CITY OF MANZANITA Manzanita Classic Street Connection Project Addendum Number 2

DATE: May 7, 2025

ENGINEERING PLANS - ADDENDUM 2

RETAINING WALL CROSS SECTION

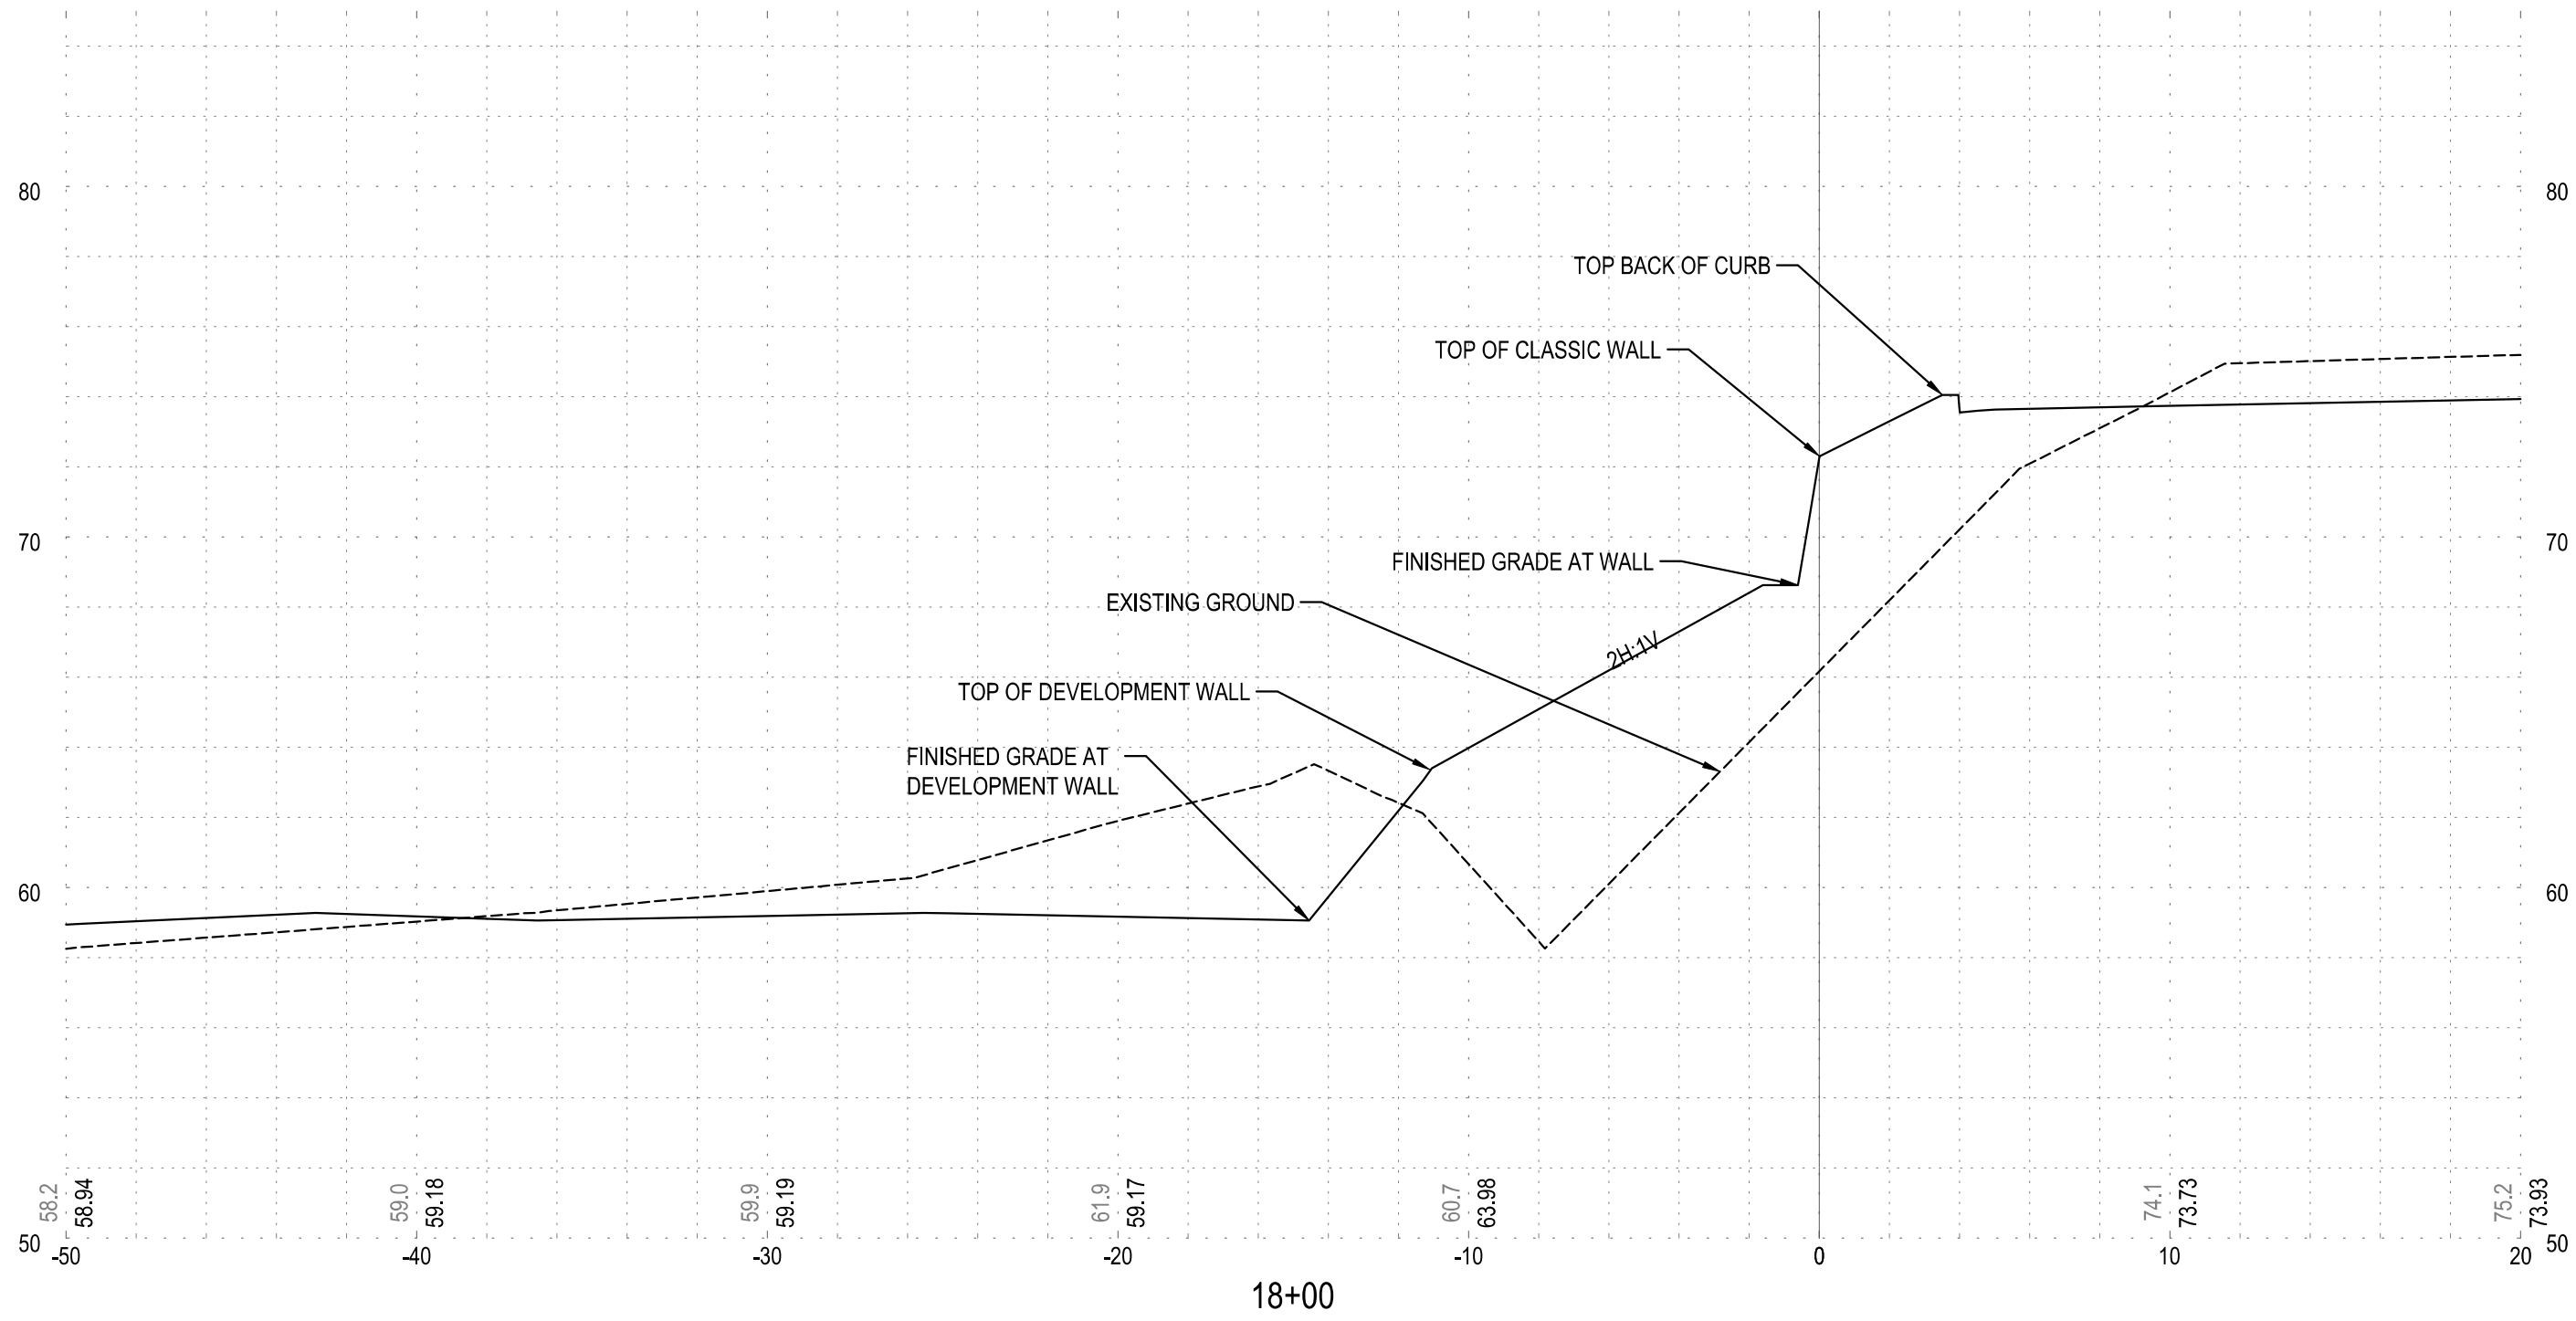
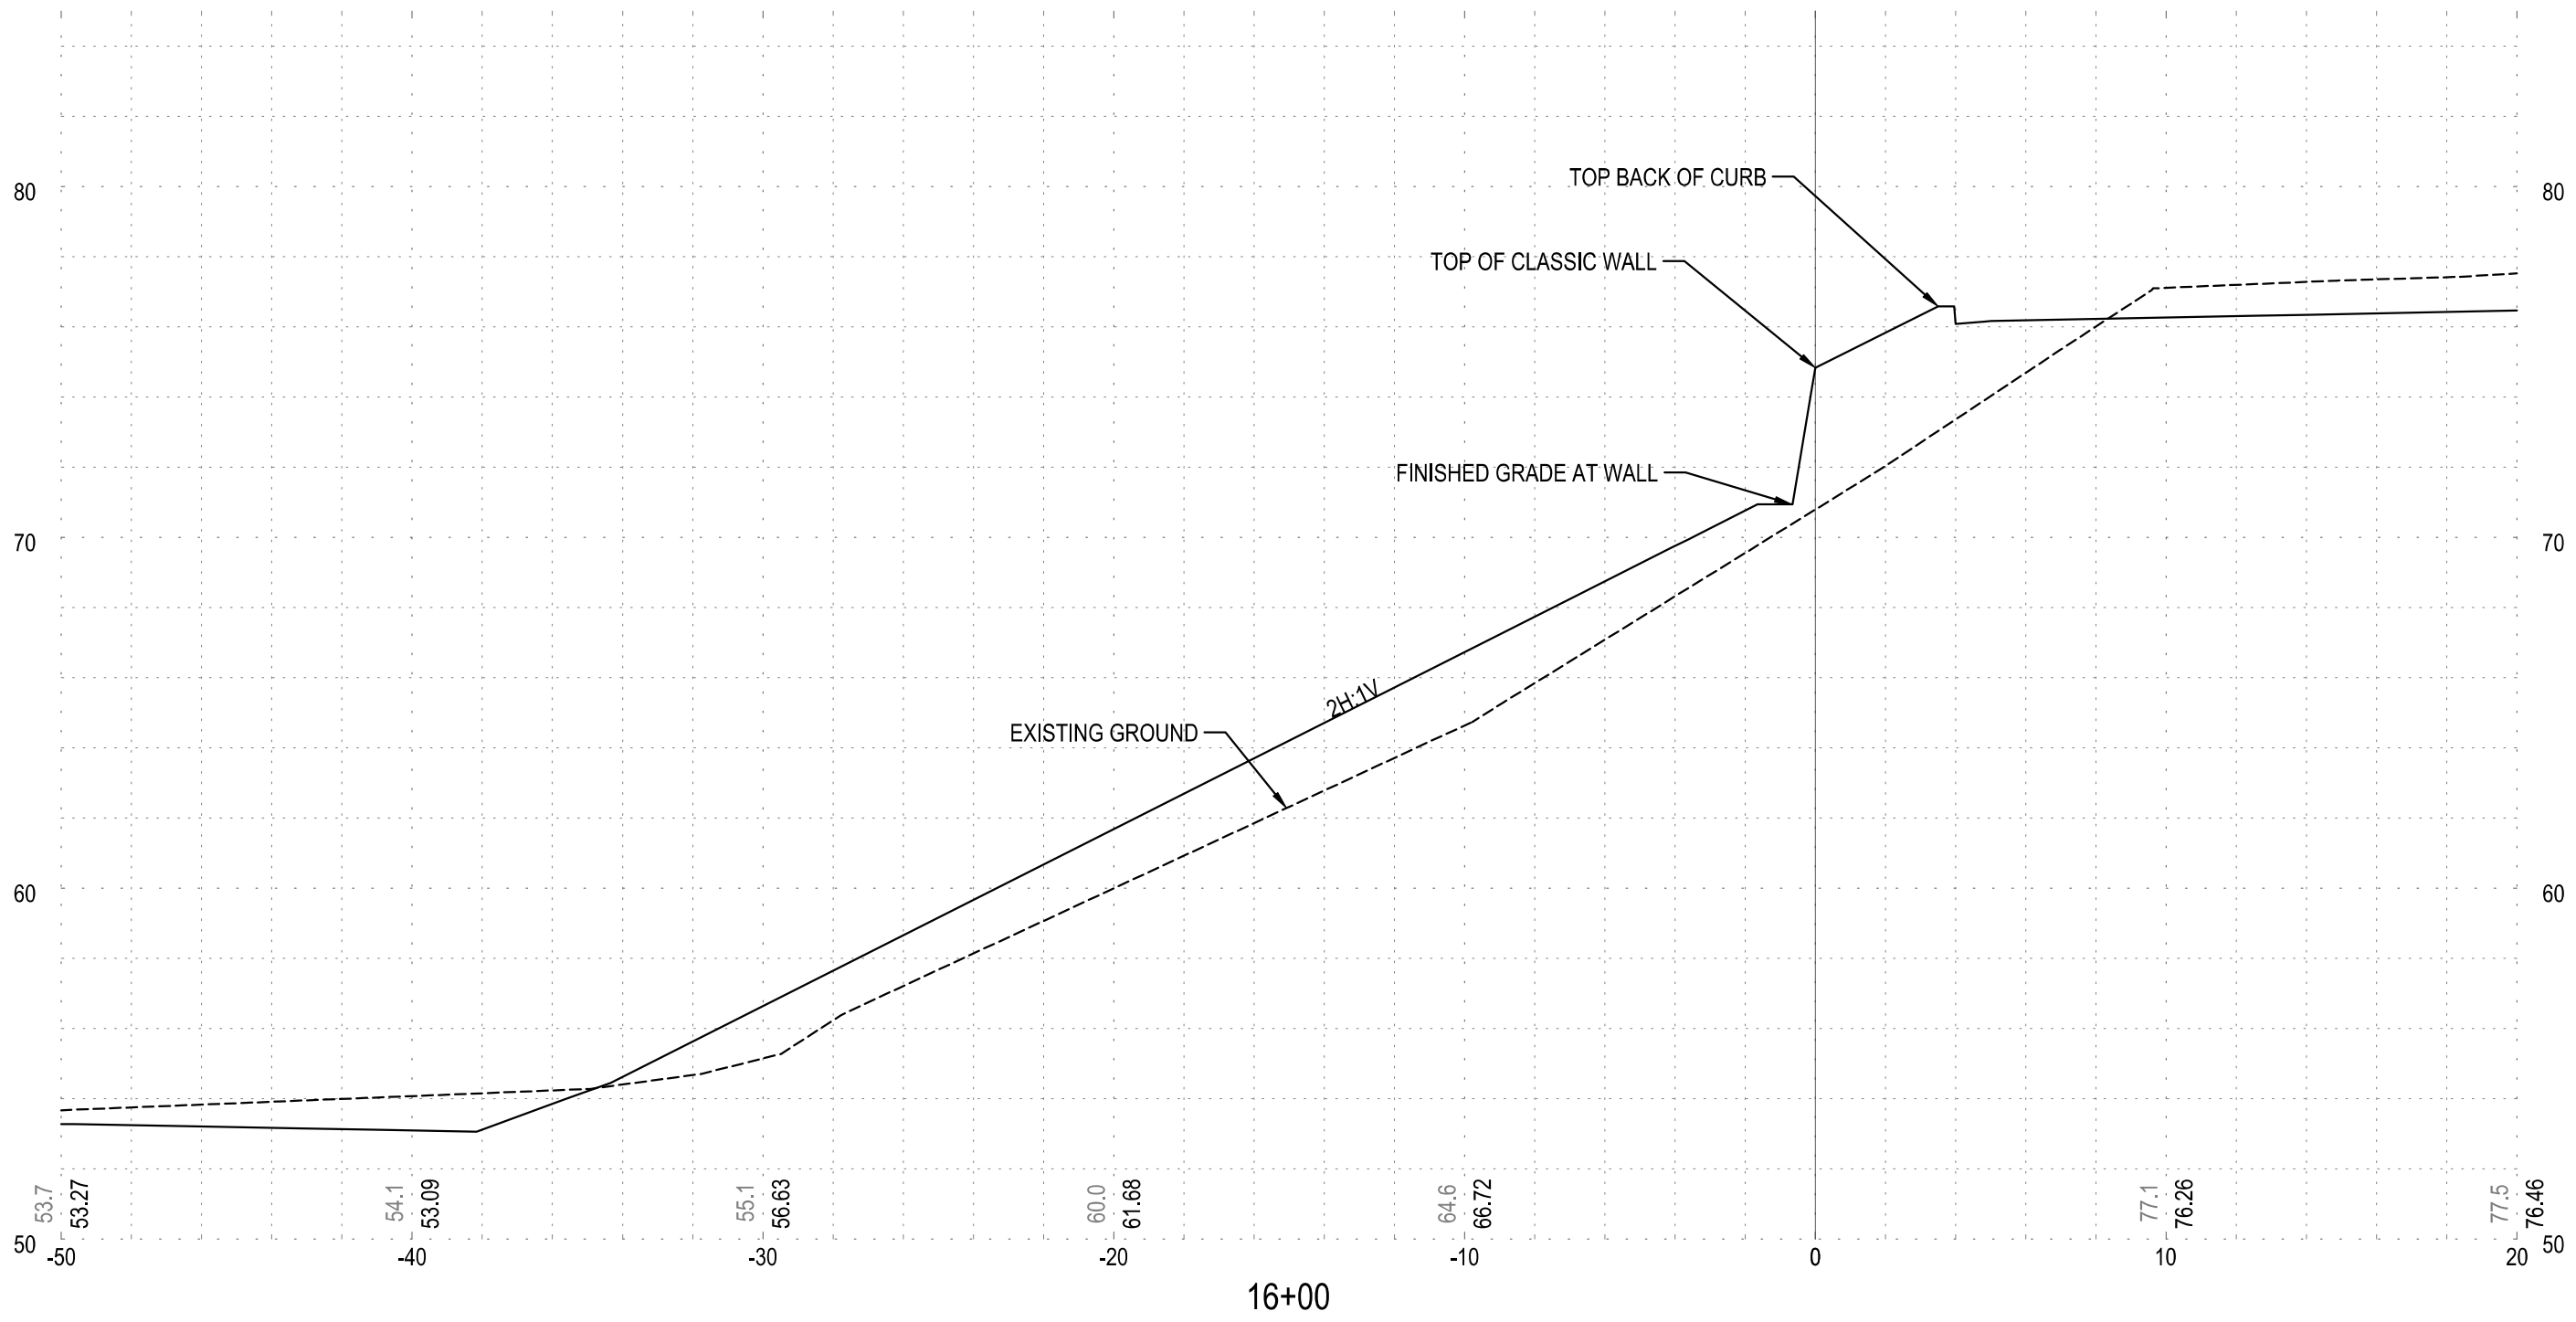
- **C601 – C603 (New)** – Retaining Wall Cross Sections: Added Cross section plan sheets along the retaining wall to help illustrate cut and fill needs along the wall.
